**BEFORE THE INDEPENDENT HEARING PANEL APPOINTED BY THE
QUEENSTOWN LAKES DISTRICT COUNCIL**

UNDER the Resource Management Act 1991 (RMA)
IN THE MATTER of the Te Pūtahi Ladies Mile Plan Variation in accordance
with section 80B and 80C, and Part 5 of Schedule 1 of the
Resource Management Act 1991.

**REPLY TO QUESTIONS ASKED OF MICHAEL LOWE
24 November 2023**

The following diagrams illustrate two scenarios:

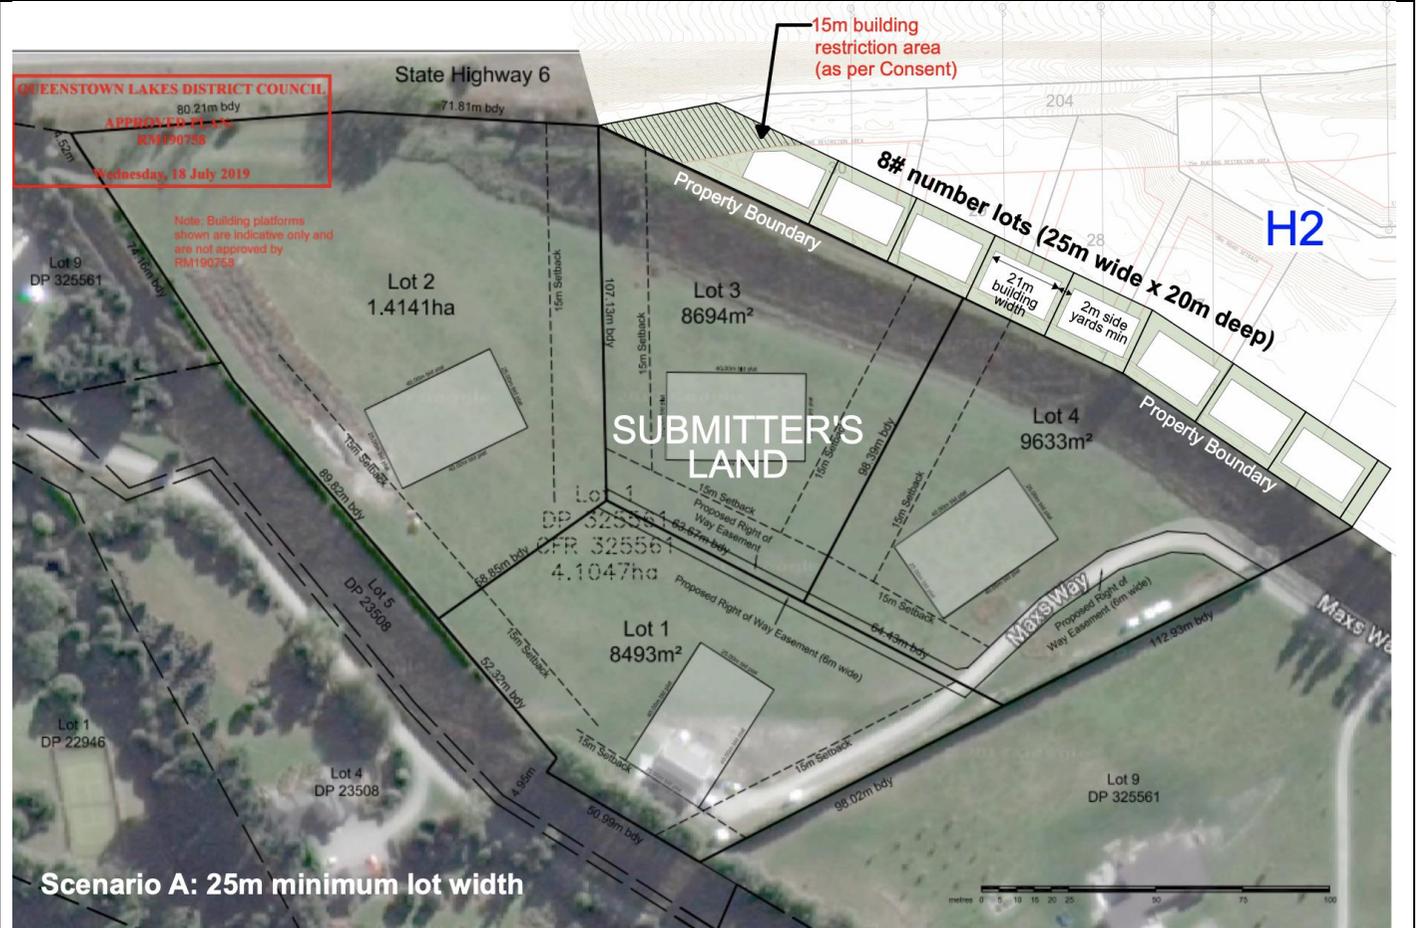
Response to questions on behalf of Corona Trust	
Question	Response
<p>Please explain how limiting the lot width in Sub Area H2 to a minimum of “20-25m” will “help reduce the potential overlooking on the Corona Trust land”? [ref: paragraph 58 (c) of rebuttal].</p>	<p>The minimum lot width was intended to prevent clustering of narrowly spaced housing fronting the H2 boundary which could result in several buildings being focused at an undesirable location or view point overlooking the submitters land. It also would limit the number of lots that could front the boundary.</p>
<p>Given there are only four building sites consented on this terrace, have you calculated the number of allotments that would result from your suggested minimum lot width rule and compared that number against the four building sites to ascertain whether your suggestion is appropriate given your recommendation at your paragraph [64] that “the provisions controlling the built form outcomes on the H2 sub-area condition adjoining Corona Trust should be amended to be generally in keeping with the existing Koko Ridge Consent”?</p>	<p>The below diagrams overlay the submitters subdivision consent alongside the existing Koko Ridge subdivision consent. I have used this to illustrate two possible outcomes along the H2 boundary.</p> <p>Scenario A: Using a 25m minimum wide lot rule (upper range of my proposed rule)</p> <p>Scenario B: Using the Koko Ridge Consent which allows buildings up to 4m from a side boundary (due to a minimum side yard setback).</p> <p>Note there is a 15m building restriction area against SH6 (shown in the Resource Consent) on H2’s land which limits the development extent on the Western end.</p> <p>Depending on the minimum lot size (20m or 25m). My study suggests the number of dwellings along the H2 boundary adjoining the submitters land could be:</p> <p>Using a 20m minimum lot size =</p> <ul style="list-style-type: none"> - Approximately 10 dwellings along the Sub-Area H2 boundary <u>VS</u> 5 dwellings as per the Koko Ridge Limited subdivision consent - This equates to approximately 4-6 dwellings fronting each of the submitter’s subdivided lots.

Scenario A: Using 25m minimum lot sizes. The building length is restricted by the lot width less the side yard rule 49.5.6.3 (a minimum of 2m) which enables a maximum 21m long building. With eight new lots this would equate up to 168m of built form along the boundary.

Scenario B: Using the existing Koko Ridge Ltd consent drawings. This enables the total built form against the boundary to be about 156m long. This assumes buildings will occupy the full width of their lots (less the 4m side yard setbacks shown on the Consent) along lots 30, 29, 28, 26, and 24 (in part).

The differences being Scenario A enables approximately 7.9% longer total building length than Scenario B.
